CAFO FACILITY INSPECTION REPORT

<u>8365130001</u> WDID NUMBER	<u>Martin Verhoeven</u> OWNER NAME	<u>Martin Verhoeven Dairy</u> FACILITY NAME
<u>CAG018001</u> NPDES NUMBER	<u>Ex. 6 Personal Privacy (PP)</u>	
<u>R8-2007-0001</u> RWQCB ORDER NO.	<u>Chino, CA 91710</u> OWNER CITY AND STATE	<u>Chino, CA 91710</u> FACILITY CITY AND STATE
<u>03/08/2013</u> SCHEDULED INSPECTION DATE	<u>Martin Verhoeven</u> OWNER CONTACT	<u>Martin Verhoeven</u> FACILITY CONTACT
<u>03/08/2013</u> ACTUAL INSPECTION DATE	<u>Ex. 6 Personal Privacy (PP)</u>	
<u>Unknown</u> RECEIVING WATER	<u>Ex. 6 Personal Privacy (PP)</u> OWNER PHONE NO.	<u>Ex. 6 Personal Privacy (PP)</u> FACILITY PHONE NO.
	<u>Ex. 6 Personal Privacy (PP)</u> FACILITY LATITUDE	<u>Ex. 6 Personal Privacy (PP)</u> FACILITY LONGITUDE

REPORT PREPARED BY: Anthony D'Angelo (PG Environmental, LLC) ON 03/27/2013

Photograph 6. View facing north from the southern Facility perimeter of lagoon Nos. 2 and 3. Note the lagoons were divided into four (4) separate lagoons by an east/west earthen berm.

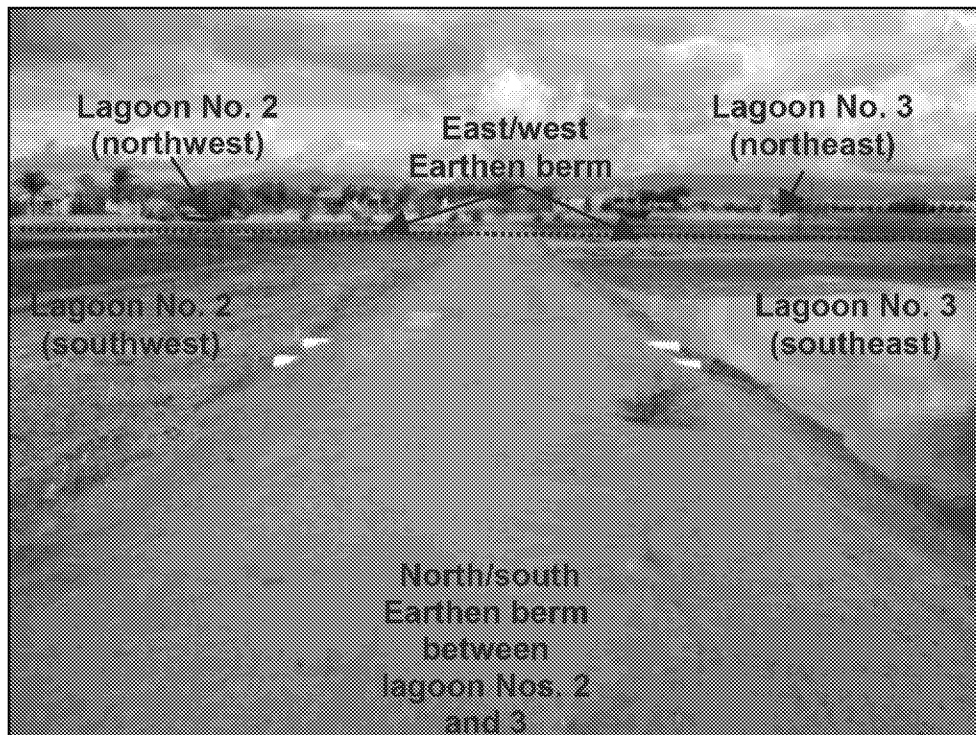
3. The EWMP was not fully implemented onsite and the containment structures had not been adequately maintained at the Facility at the time of the inspection, as required by Provisions VII.C.3.a and Provision VII.C.3.b of the Permit (refer to Photos 6, 11, 12, and 13).

2. The EWMP was not fully implemented onsite at the Facility or reflective of current Facility conditions as required by the Permit. Section I - 'Introduction' of the EWMP identifies three (3) lagoons at the Facility: Lagoon No. 1 in the southern portion of the Facility, and lagoon Nos. 2 and 3 in the eastern portion of the Facility. The inspector observed, during the inspection, that an east/west earthen berm had been constructed to divide lagoon Nos. 2 and 3 into four (4) separate lagoons (refer to Photos 6, 11, 12, and 13). Provision VII.C.3.b of the Permit states that "the discharger shall develop and fully implement an Engineered Waste Management Plan (EWMP) acceptable to the Executive Officer." Due to the separation of lagoon Nos. 2 and 3 into four (4) separate lagoons, the Discharger was not fully implementing the approved EWMP and Site Plan which only identified a total of three (3) containment structures not five (5) observed at the time of the inspection. The Discharger shall fully implement the EWMP as required by Provision VII.C.3.b of the Permit. This issue was identified in a previous inspection conducted on May 7, 2012.

Photograph 10. View facing southeast from the northwest corner of the southeast portion of lagoon No. 3. Note accumulated solids were observed in the lagoon.

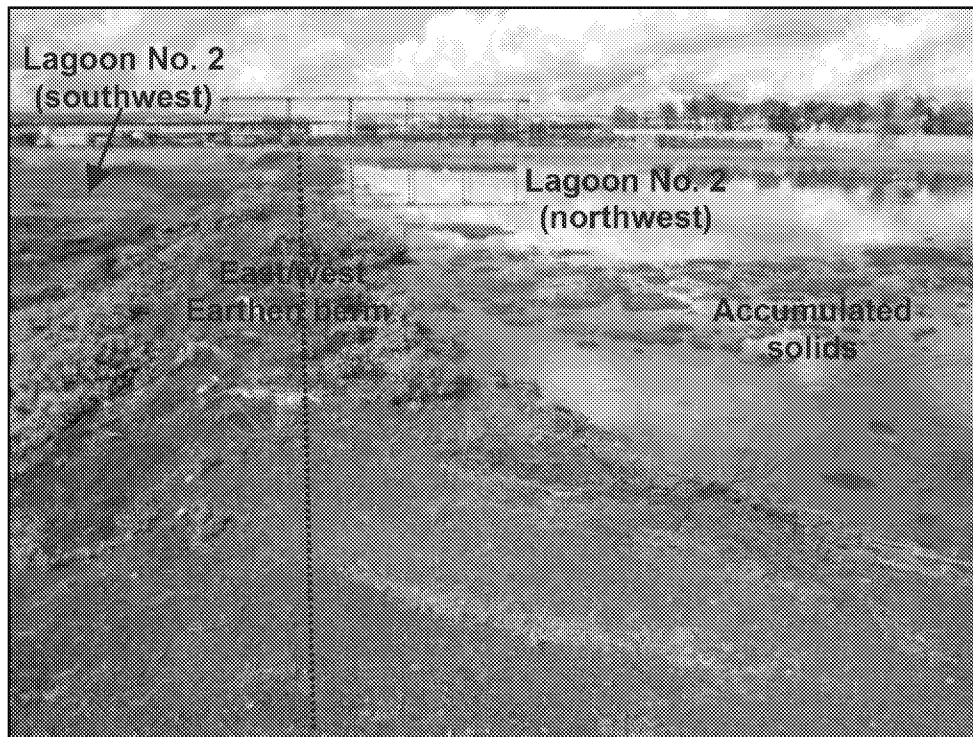
5. Accumulated manure solids were observed in lagoon Nos. 1, 2, and 3 in the southern and eastern portions of the Facility (refer to Photos 10, 11, 16, and 17). The Discharger must design and maintain all containment structures per the EWMP as required by Provision VII.C.3.a of the Permit.

3. The inspector observed, during the inspection, accumulated manure solids in lagoon No. 1 in the southern portion of the Facility, as well as in the four (4) lagoons (identified in the EWMP and Site Plan as lagoon Nos. 2 and 3) (refer to Photos 10, 11, 16, and 17). This finding is addressed in Item No. 3 of the 'Engineered Waste Management Plan Review' section of this report.

Photograph 16. View facing south of the northeast portion of lagoon No. 3. Note the accumulated solids in the lagoon. Also note the lagoon did not contain a depth marker.

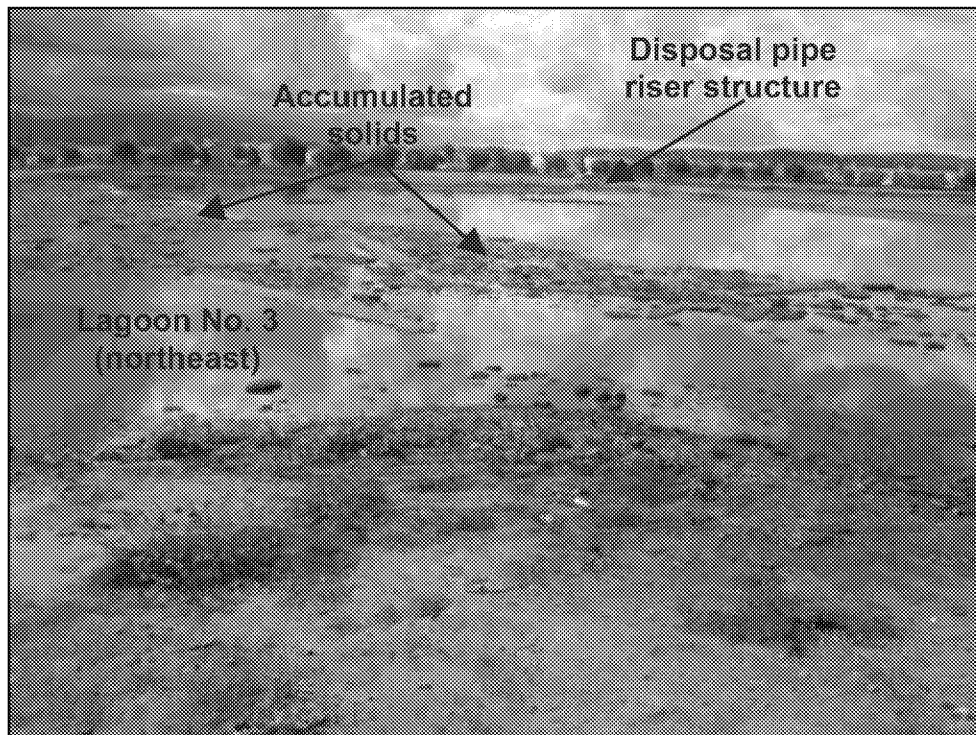
- Depth markers were not installed in lagoon Nos. 1, 2, and 3 (refer to Photos 16 through 19)
- Annual Reports for the previous five (5) years were not retained or available for review at the time of the inspection
- Weekly Storm Water Management Structure visual inspection documentation was not available for review at the time of the inspection
- Manure Tracking Manifests were not available for review at the time of the inspection
- The Engineered Waste Management Plan (EWMP) was not available for review at the time of the inspection
- The EWMP was not fully implemented onsite at the Facility (i.e., containment structures) (refer to Photos 6, 11, 12, and 13)
- A previous release of manure offsite onto the Eucalyptus Avenue right-of-way was observed along the southern Facility perimeter (refer to Photos 20, 21, and 22)

1. Depth markers were not installed in lagoon No. 1, located in the south-central portion of the Facility, or in the northern sections of lagoon Nos. 2 and 3 located in the eastern portion of the Facility, as required by Permit Attachment B - Monitoring and Reporting Program, Section I.B.1 (refer to Photos 16 through 19). Lagoon Nos. 2 and 3 had been divided in half by an east/west earthen berm; therefore, dividing lagoon Nos. 2 and 3 into four (4) separate lagoons (refer to Photos 6, 11, 12, and 13). This is a recurring issue identified in a previous inspection conducted on May 7, 2012.

Photograph 21. View facing west of a release of manure offsite to the south from corral No. 7 onto the Eucalyptus Avenue right-of-way.

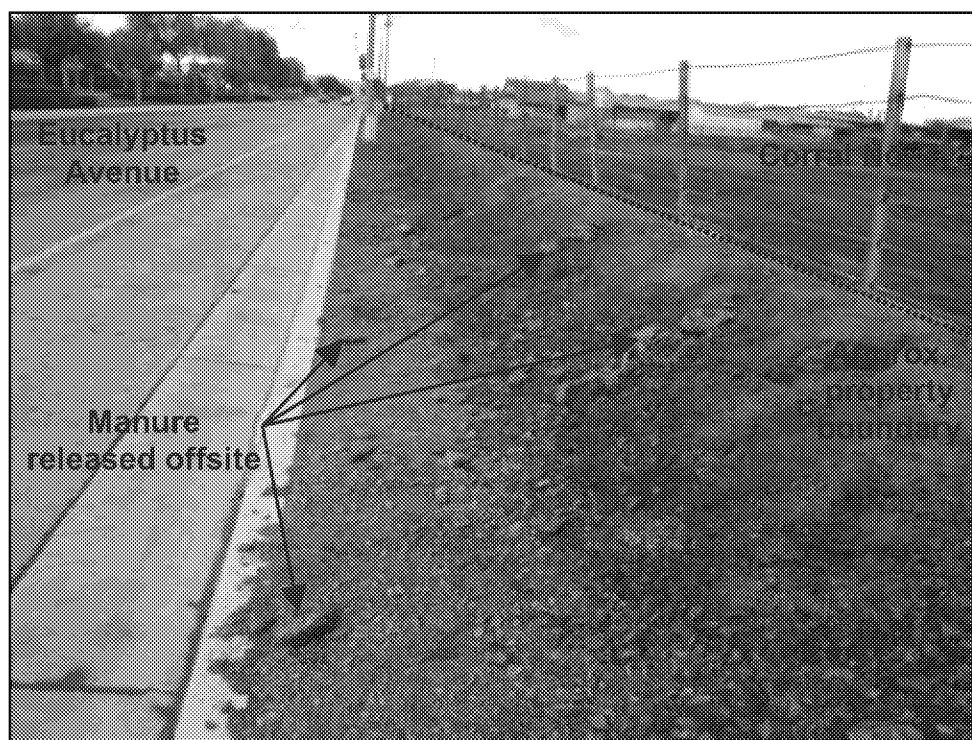
4. A release of manure offsite to the south onto the Eucalyptus Avenue right-of-way, was observed by the inspector, at the time of the inspection (refer to Photos 20, 21, and 22). A release of manure offsite to land and property not owned or controlled by the Discharger is prohibited by Discharge Prohibitions IV.A-B of the Permit.

1. The inspector observed, during the inspection, a release of manure offsite to the south from corral No. 7 onto the Eucalyptus Avenue right-of-way (refer to Photos 20, 21, and 22). The inspector did not receive any information regarding the offsite release of manure from the Facility representatives. Discharge Prohibition IV.B of the Permit states "disposal of manure to land is prohibited." In addition, Effluent Limitations and Discharge Specification V.1.a of the Permit specifies that pollutants may be discharged from the Facility if "the production area is designed, constructed, operated, and maintained to contain all manure, litter, and process wastewater including the runoff and the direct precipitation from a 25-year, 24-hour rainfall event."

Photograph 23. View facing southwest of a soil stockpile containing livestock skeletal remains in the unused dirt area in the north-central portion of the Facility, adjacent to lagoon No. 2.

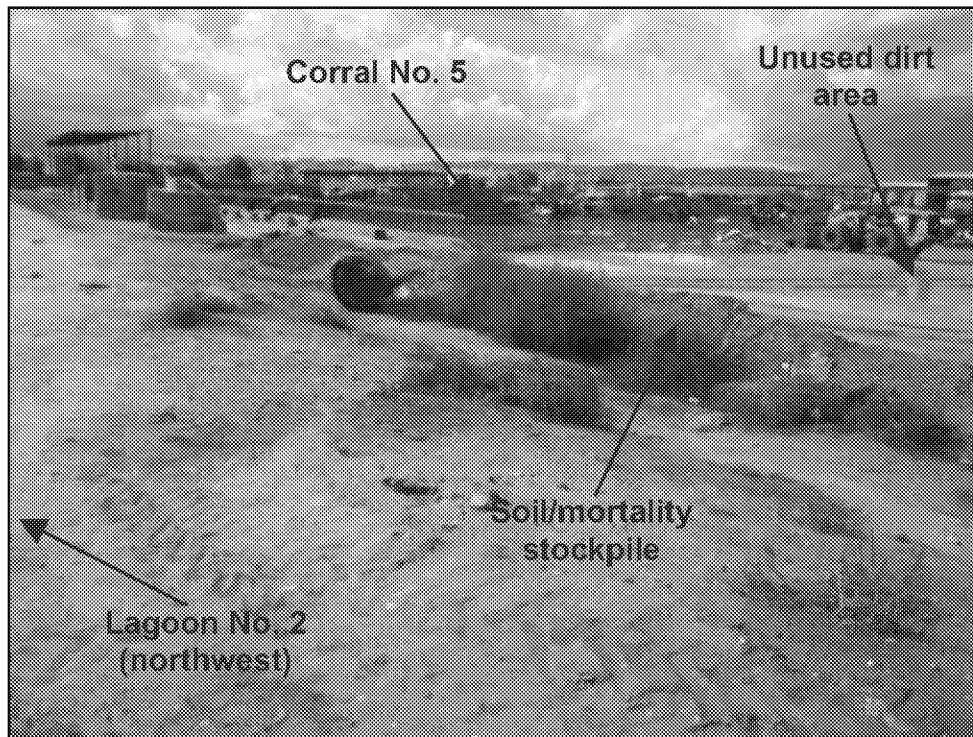
- A stockpile of skeletal remains (i.e., livestock mortalities) was observed on the northwest side of lagoon No. 2 (refer to Photos 23 through 27)
- Accumulated manure solids were observed in lagoons Nos. 2 and 3 (refer to Photos 10, 11, 16, and 17)

2. The inspector observed, during the inspection, a soil stockpile containing skeletal remains (i.e., livestock mortalities) on the west side of the northwest lagoon (north side of lagoon No. 2) in the unused dirt area (refer to Photos 23 through 27). The soil stockpile and skeletal remains appeared to be contained onsite; however, storm water runoff from the stockpile most likely would flow south through the eastern corrals and enter lagoon No. 1. Discharge Prohibition IV.F of the Permit states "the disposal of any mortality in any process wastewater system is prohibited. Mortalities shall be handled in such a way as to prevent the discharge of pollutants to waters of the state."
